1984 Corvette: Service Bulletin: Broken Window Regulator Tapes

Subject: Broken Window Regulator Tapes

Model and Year: 1984 Corvette

Bulletin No: 84-3

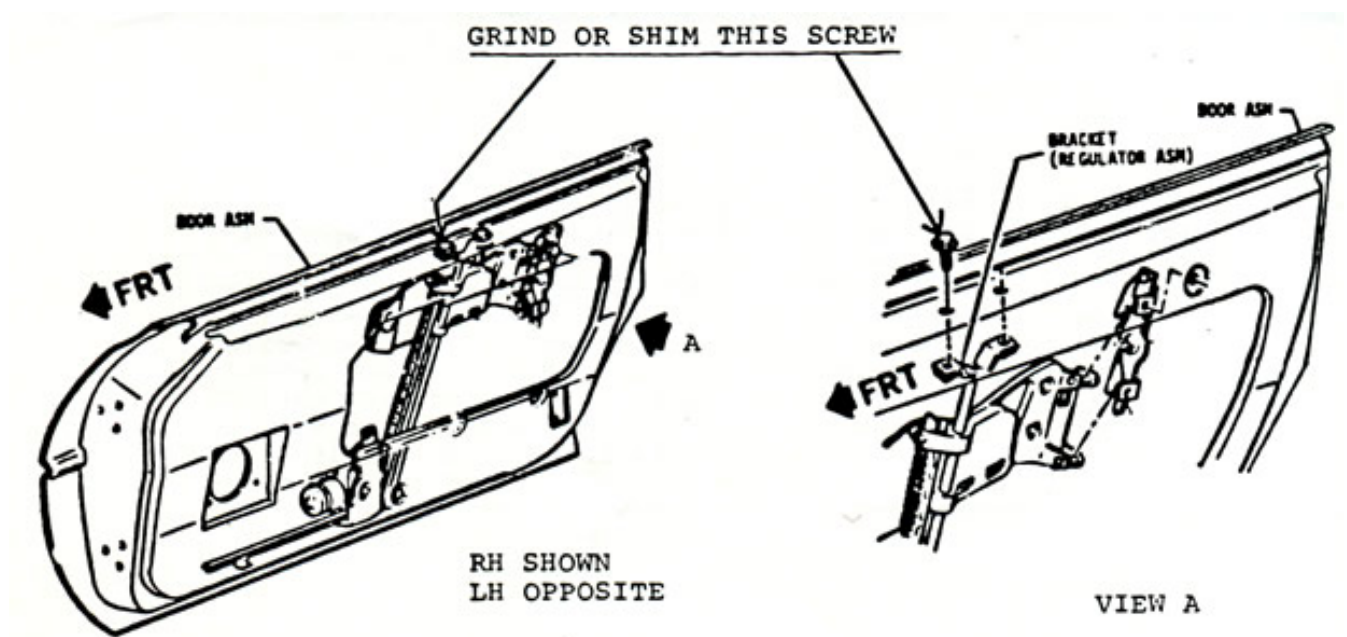
Whenever a vehicle requires service of door components, inspect for interference between the forward upper attaching screw and the upper end of the tape drive. if interference exists, one of the following options should be performed:

This is to prevent contact between the bottom of the screw and the upper end of the tape drive. if this contact exists, excessive stress is created in the tape and could cause a failure.

1. Add a washer (P/N 14038397), or equivalent, under the upper forward attaching screw (See Illustration).
2. Remove the forward attaching screw (P/N 11503800) and grind approximately 3mm from the threaded end.
